To: T10 Technical Committee
From: Luben Tuikov, Vitesse Semiconductor (ltuikov@vitesse.com)
Date: 18 October 2006
Subject: 06-460r0 SAM-4 Time bounds of task states

Suggested changes

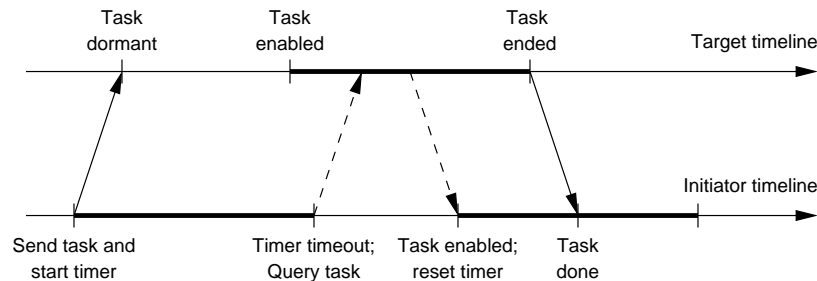
The problem is that the timeout value(s) returned by the target as described in 05-284r3 currently does not correspond to any task state. What then does such a timeout value mean *in the context of SAM-4 and SPC-4?*

A task executing at the target device and completing with the application client needs to be represented by *at least two* task states (TASK ENABLED and TASK ENDED) at the target. This implies that the timeout value specifies time spent in at least those two states.

The suggested changes are that the timeout value specify time spent in the TASK ENABLED and TASK ENDED task state. This of course implies that TASK ENABLED and TASK ENDED state is bounded in time. This is not a problem since the time bounds are not specified in the architecture. As far as the architecture is concerned a time bound of 100 million years is just as good as 100 microseconds, for example.
